RECOMMENDATIONS FOR SUSTAINABLE SITE DESIGN

Green Landscape Plan Final

JUNE KEY DELTA HOUSE

re: Land Use Review Comment Response

1/8"=1'-0" UTILITY PLAN

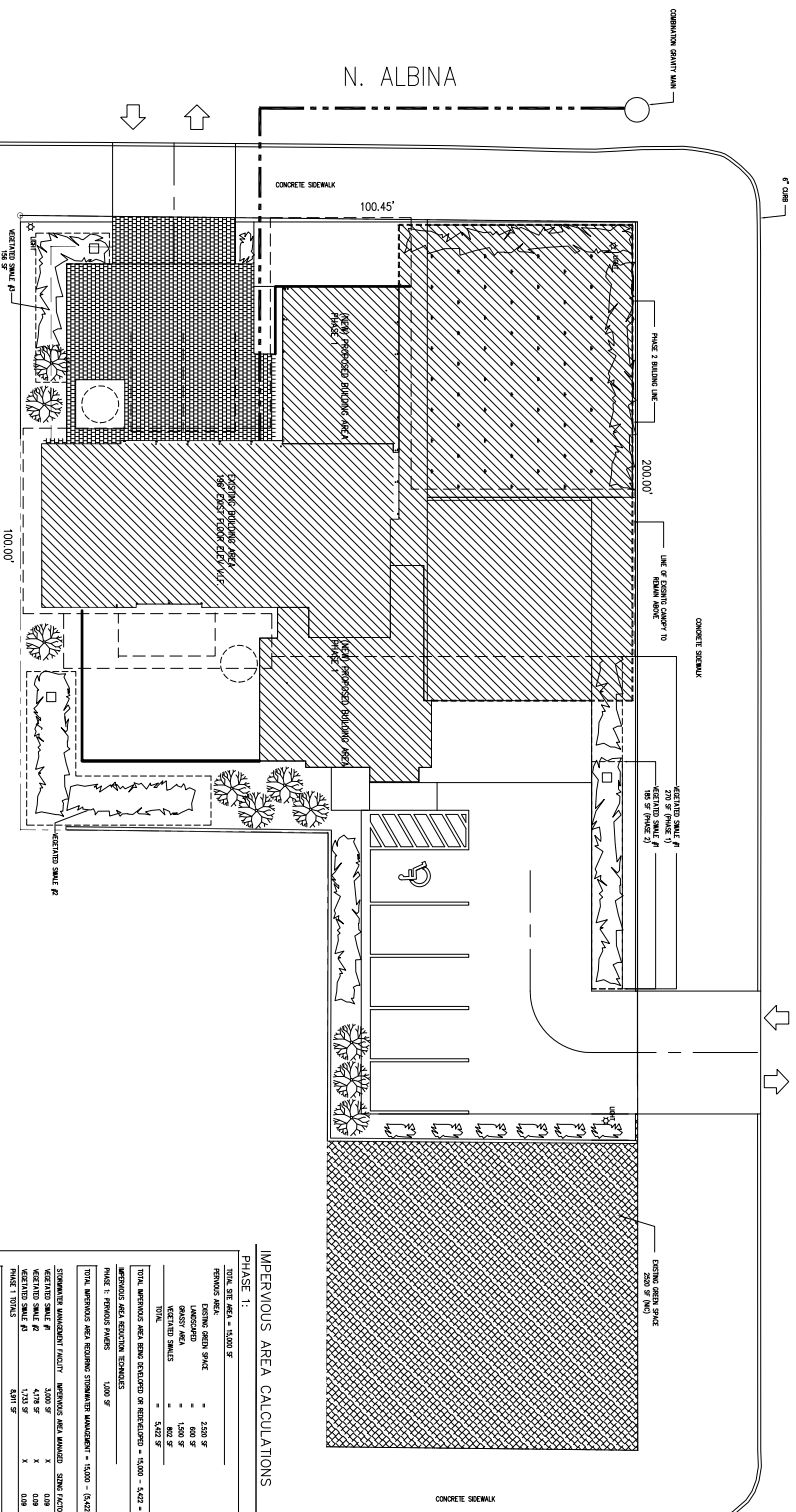
1. Revised Stormwater Calculations. Stormwater calculations for this proposal were based on the Simplified design approach. In its review of this proposal, BDS Site Development states that this approach cannot be used for sites greater than 10,000 square feet. Instead, the Presumptive design approach or, if approved by BES, the Performance design approach must be used for stormwater calculations.

Please provide revised calculations for the stormwater facility that include the following:

- *The Utility Plan attached shows the single Sanitary connection line to the combination gravity main in N. Albina, that the City plumbing records show on permit file #78948 (also referenced in the Pre-application Conference Response Letter dated April 2, 2008). This connection was also approved in the EA 08-112436 comments. Consequently, since there is a single connection on the site no pipes cross. Please refer to sheet A002 enclosed.*
- *Stormwater is completely managed with on-site infiltration.*
- *No street improvements apply.*

$$\text{IMPERVIOUS AREA MANAGED} = 7,966 \text{ SF GREATER THAN IMPERVIOUS AREA} = 7,477 \text{ SF}$$
